Date: March 2, 2023
To: Board of Directors
From: Robert Miller, P.E., General Manger
Re: Corrections to 2008 Engineering Report

Las Ventanas Ranch Mutual Benefit Water Company

Technical Engineering Report for a Domestic Water System

June, 2008
Strikeout updates dated March 1, 2023

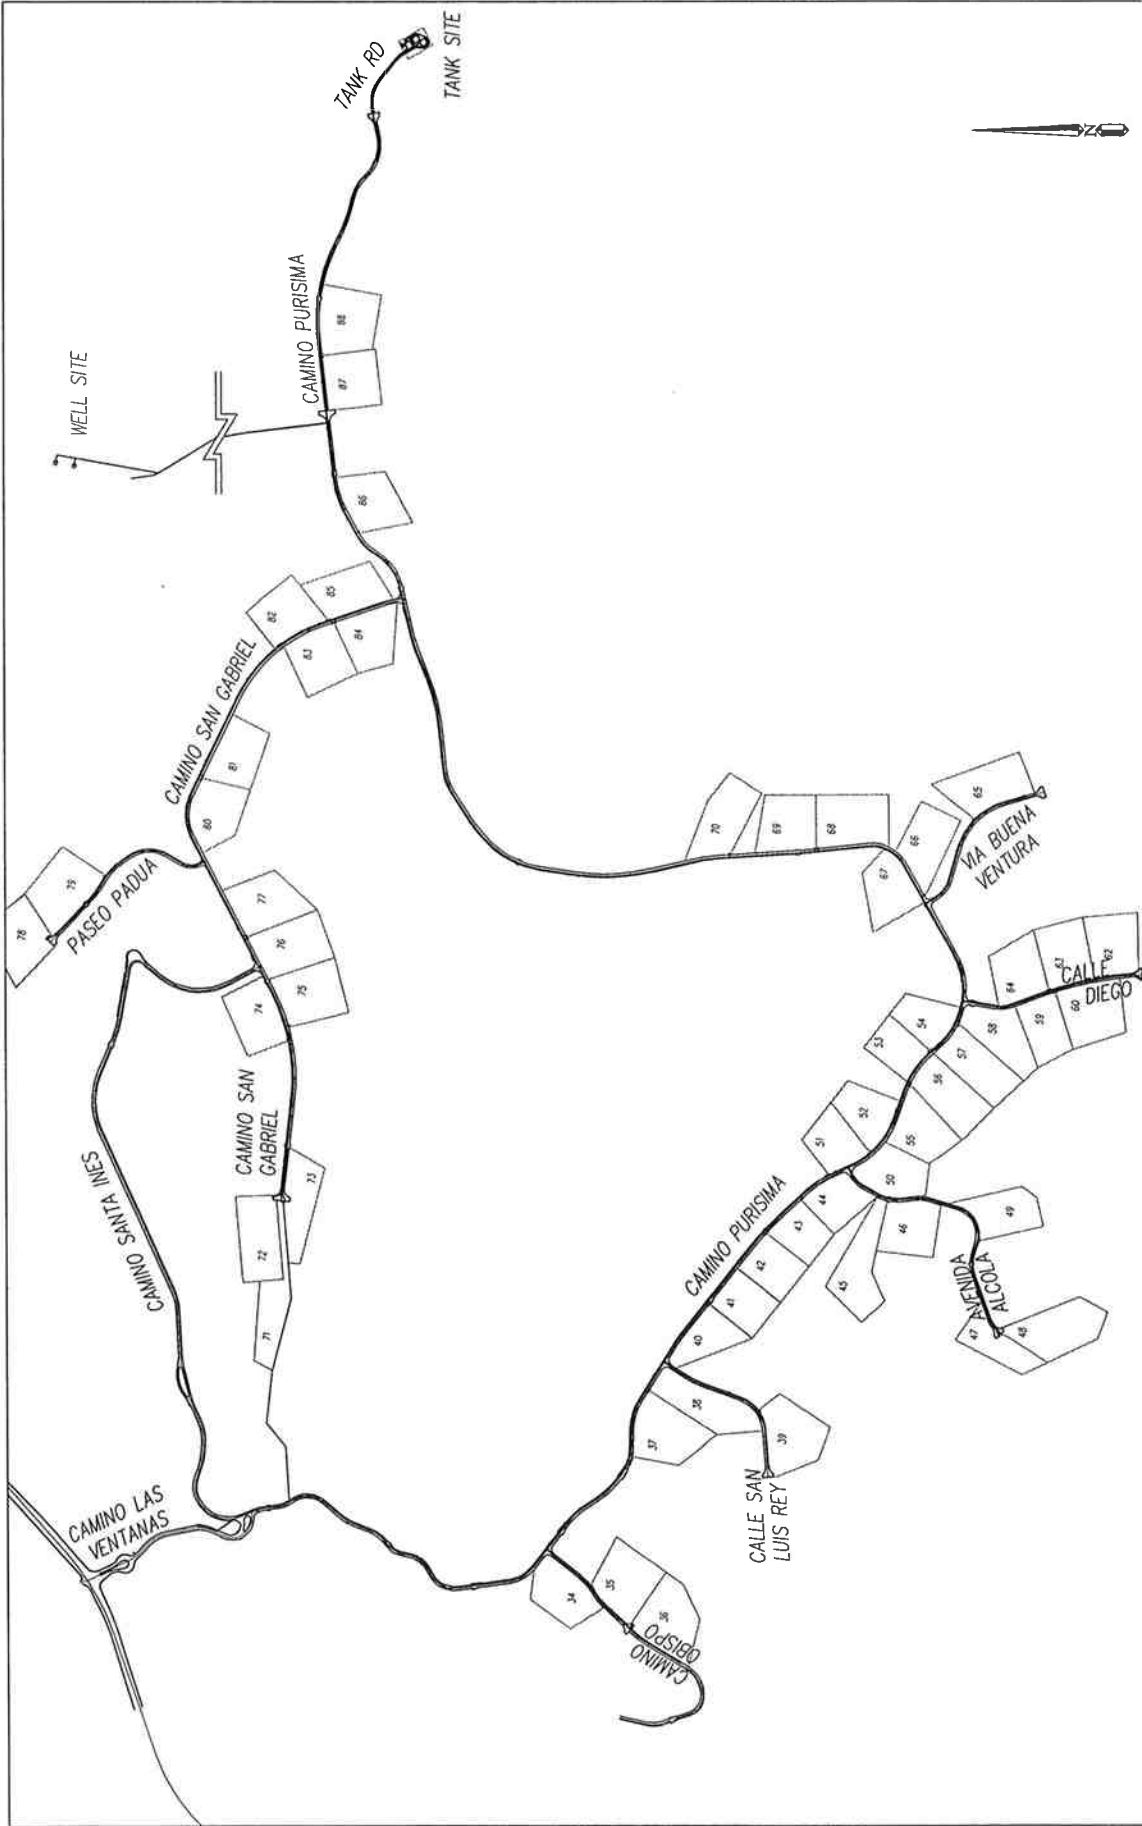
Water Quantity: Water supply for the Company consists of two wells located approximately 240 feet south of the covered bridge on the property and east of Lopez Drive. The wells are designated as ~~Well A~~ (primary) and ~~Well B~~ (secondary).
Well B Well A

The secondary well (~~Well B~~) located approximately 168 ft ~~south~~ ^{north} of ~~Well A~~, was drilled on October 10, 1975. It was originally designated the Pennington Well. (State well number is not registered on the available drilling log). ~~Well B~~ was drilled to a completed depth of 80'; the static water level is 22' below the ground surface. The well has a 10-inch casing. The annular seal is cemented down to 35', and there is a pea gravel filter pack that extends from 35' to 80'. A Well Completion Report for this well is included as Exhibit A.

1 W-2 LOCATION OF WELLHEADS A & B SCALE 1" = 50'

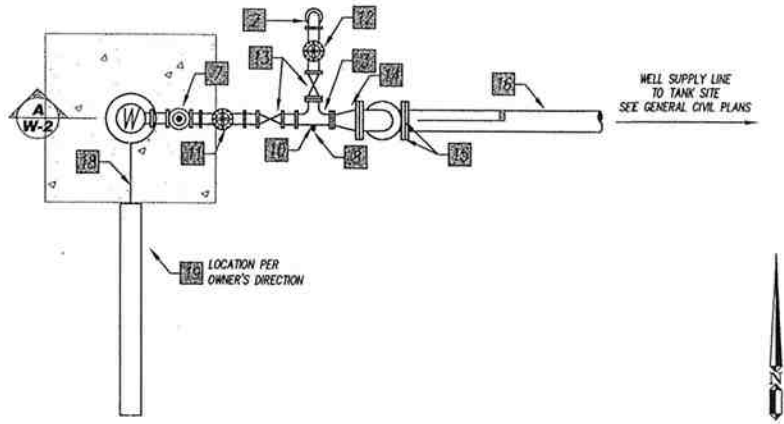
(Well B) (Well A)
